Changes in EOS 0610i NET/DUO from Firmware revision 1.6

EOS 0610i NET/DUO Firmware v1.5/v1.6 Addendum

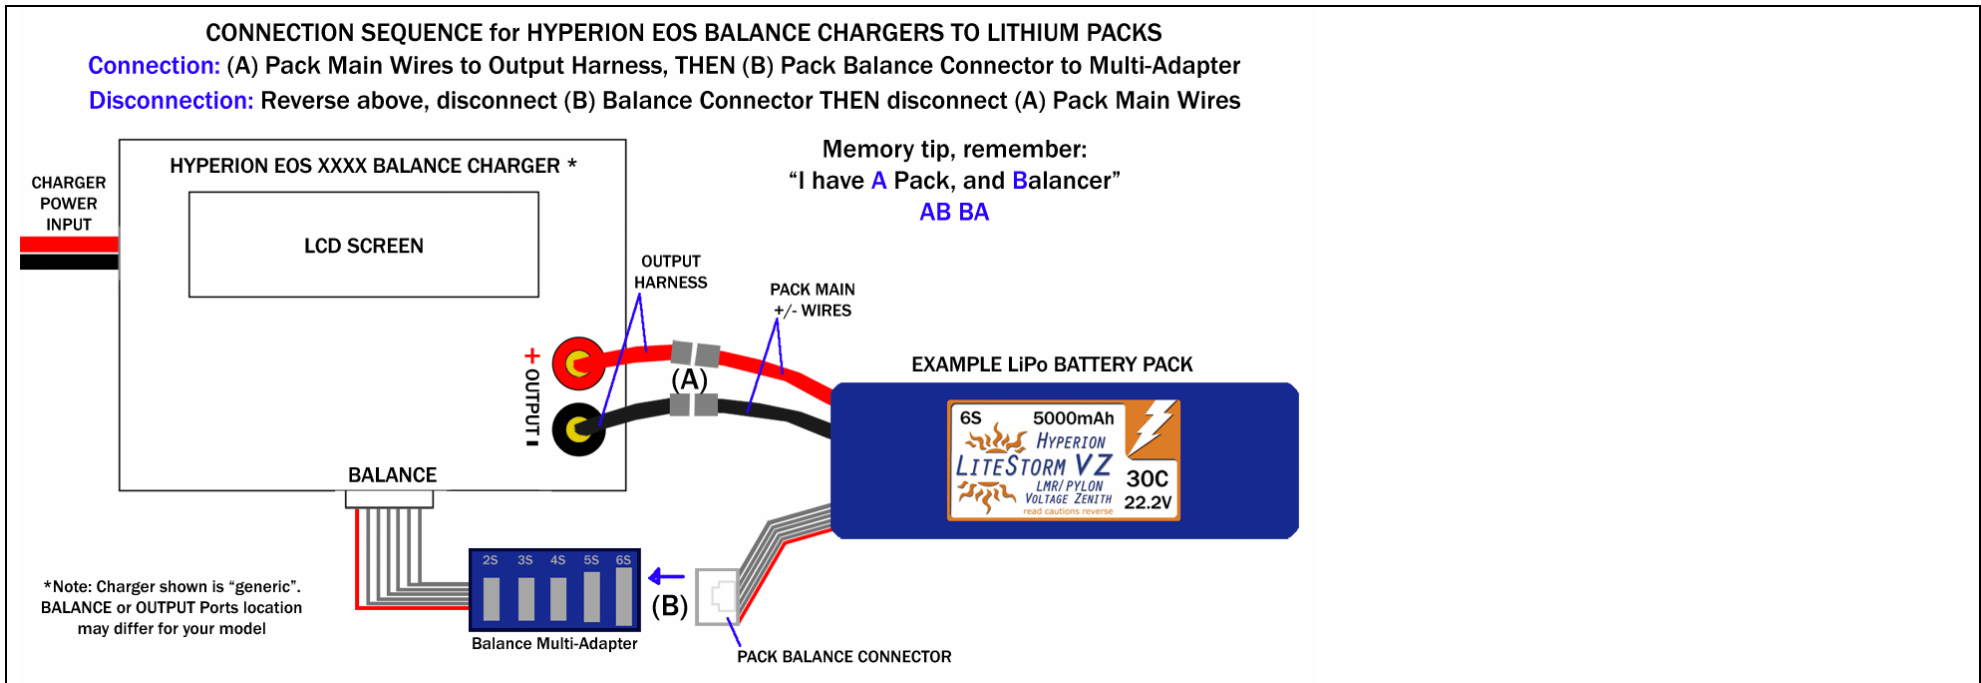
(1) **CHARGER INTERNAL PROTECTION UPGRADE** – The connection sequence of Lithium Packs with Balancer Connector (LiPo, LiFePO4) has an impact on the components inside the charger. The connection sequence shown below reduces surges which occur at pack connection time, greatly reducing possibility of damage to charger components:

In v1.6 NET/DUO firmware, additional protection is provided such that even if correct connection sequence is NOT followed, chances of charger damage are much reduced. Even so, it is always recommended that you follow the connection/disconnection (AB-BA) sequence as shown above.

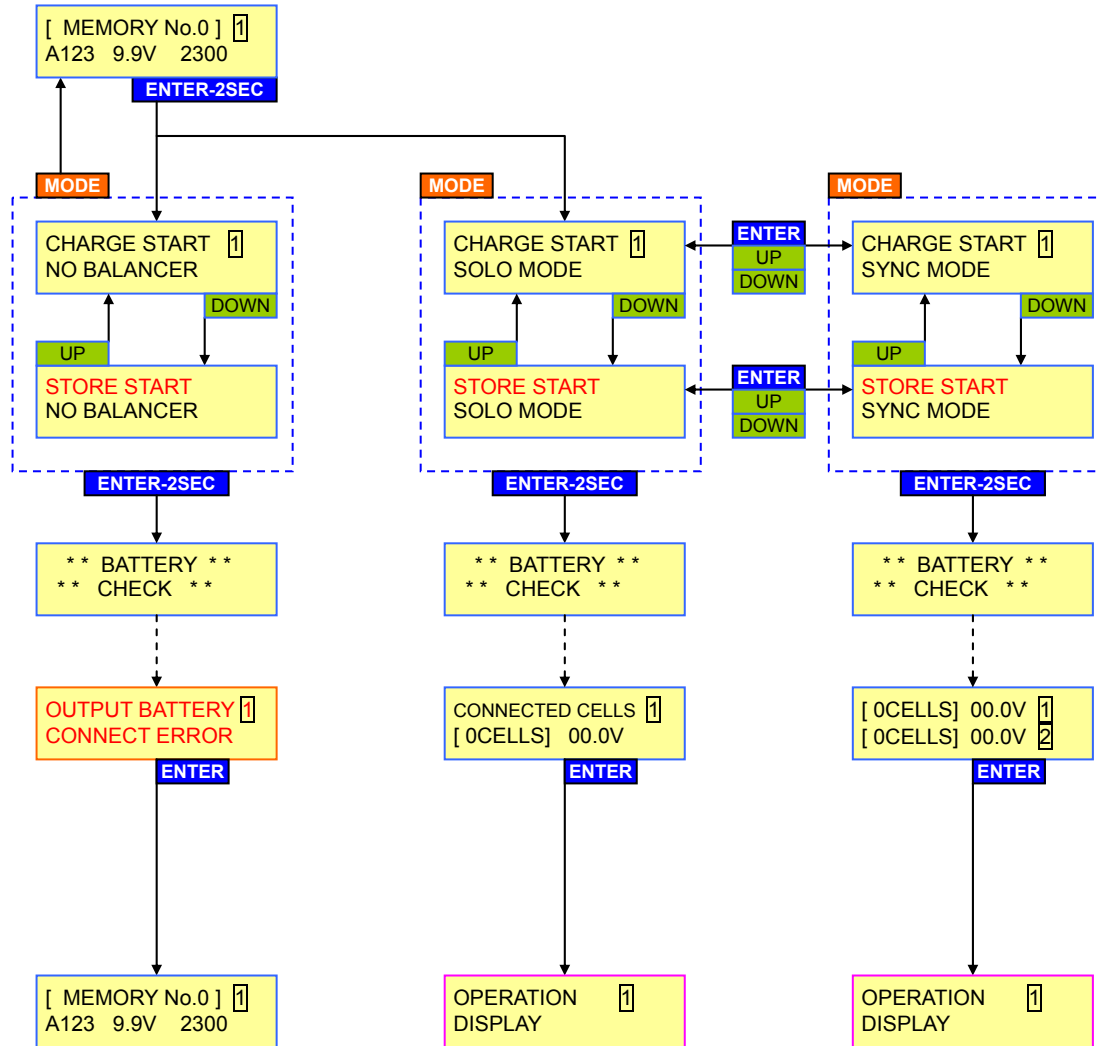
* **Why does the charger continue to show current flowing for Li~ charging after the END buzzer?**

At END of Li~ CC-CV charge, the charger MUST maintain a small current in order to finish the final few % of capacity, maintain cell balance and avoid discharge via the balance circuit until pack is removed from the charger. You may see the mA-in counter rise as a few low cells receive their final charge-in capacity. Due to a programming limitation in previous firmware versions, this was shown with "TRK" in the display (as it is when NiMH "trickle" is in effect at charge end). HOWEVER, THIS IS IN NO WAY a "trickle charge" as commonly defined for NiMH, etc. If you see "TRK" in this case it means your battery is ready to be disconnected, only. Always disconnect as soon as possible after End Buzzer.

Update to v1.6 firmware as soon as possible to further protect and perfect your charger. From v1.6 firmware, "TRK" is replaced and "BLC" is shown instead, to better indicate that any current flowing is mostly holding balance state, rather than charging in a normal sense.
